I. Amendments to th Drawings

Annotated copies of Figures 5 and 10 showing the drawing corrections and an amended formal drawing correction copy of Figure 5 are included in this amendment.

Fig. 5

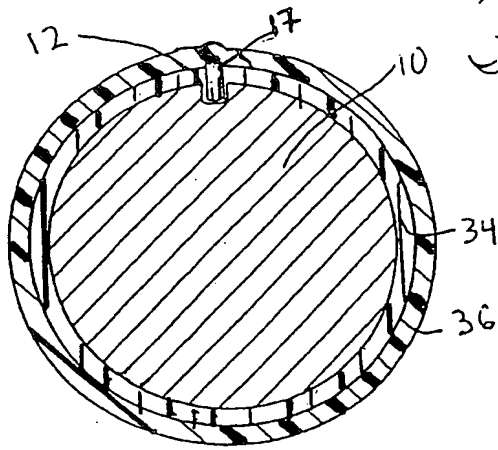
Figure 5 has been amended to show the protruding portion of the second layer 36 as a continuation of the second layer 36.

FIGURE 10

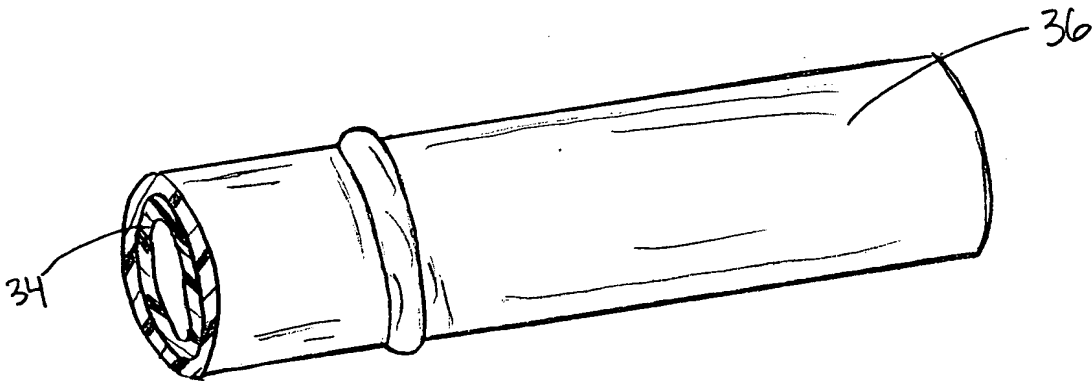
Figure 10 has been amended to show the side view of the drive shaft shown in Figure 7.
